Technical *data*

CT 939 K2/K3 & CT1120K1 timing belt kit, used for example in:
VW / Audi 2.5 TDI 5 cyl.

Fig. 1
Washer

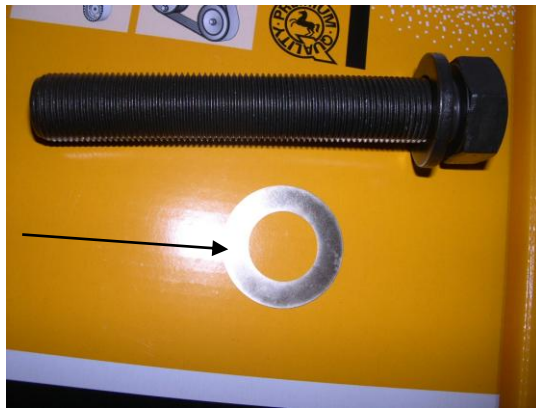
In accordance with the updated equipment status, the timing belt kit contains a thin washer (diamond-coated) that was not previously installed in the vehicle.

According to the VW/Audi catalog, this special washer (4) is to be installed between the crankshaft drive wheel (3) and the torsional vibration damper (5). This is intended to improve the co-efficient of friction.
